Memorandum

RE: Correction of Resolution MCPB No. 22-028, Site Plan No. 820220020
Park Montgomery

MCPB No.22-028
Site Plan No. 820220020
Park Montgomery
Date of Hearing: March 17, 2022

CORRECTED RESOLUTION

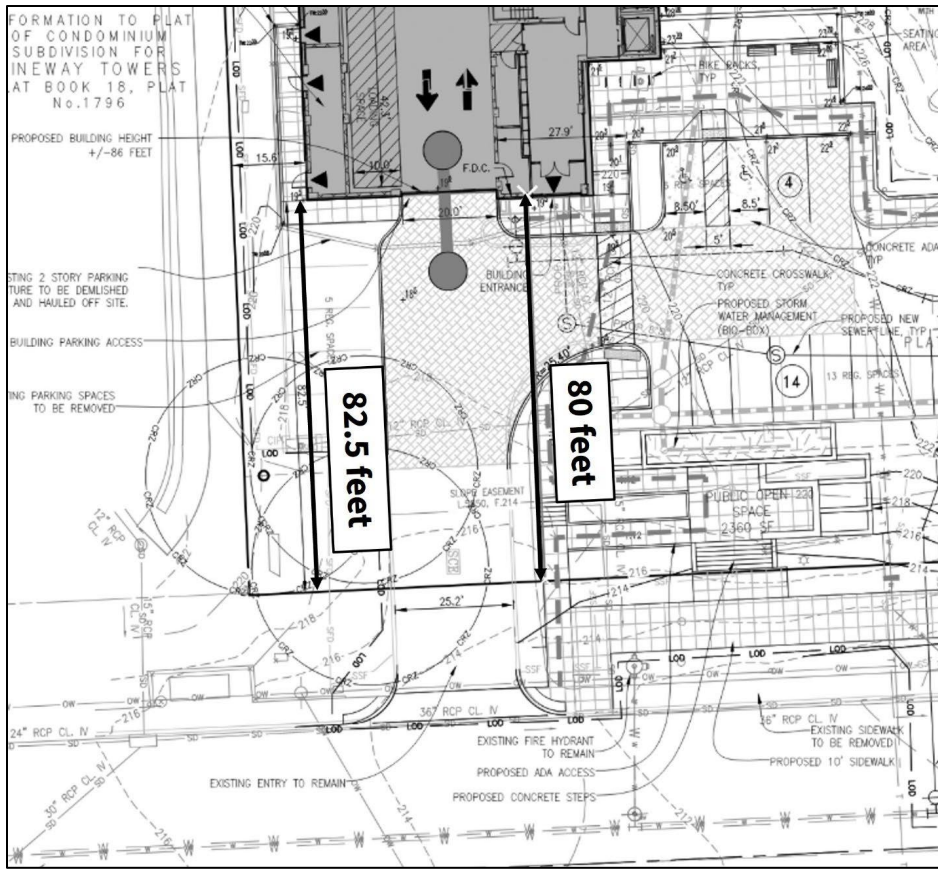
The corrected resolution herein resolves an error within the data table that demonstrates the Project's compliance with Zoning Ordinance development standards. The table shows a minimum setback of 82 feet and it should have been 80 feet. An outline of corrections is as follows:

- Page 10: Corrects Table 1, minimum front setback from 82 feet to 80 feet, which reflects the actual setback and building footprint as shown on the Applicant's drawings at the time of Planning Board approval and included as Attachment D of the original Staff Report. The discrepancy is annotated in Figure 1 below.

Development Standard	Approved per LMA H-140	Proposed
Tract Area	n/a	150,087 sf (3.44 acres)
Prior Dedication	n/a	6,740 sf (0.15 acres)
Proposed Dedication	n/a	0
Site Area	n/a	143,347 sf (3.29 acres)
Mapped Density CRTF 1.6 C-0.0 R-1.6 H-140'		
Residential (GFA/ FAR)	140,139 sf (1.6)	237,737 sf (1.58)
Commercial (GFA/FAR)	0	0
Total GFA/FAR	140,139 sf (1.6)	237,737 sf (1.58)
MPDU requirement	15% ¹	15.5%
Building Height, max average	Existing building: 140 ft Proposed building: 98 ft ²	Existing building: 137 ft Proposed building: 90 ft
Public Open Space (min s.f.)	5%	5% (1.6% or 2,360 sf onsite and remainder by payment of a fee) ³
Minimum Setbacks (ft)		
Front	0 ft	82-80 ft
Side	10 ft	15 ft
Rear	30 ft	34 ft
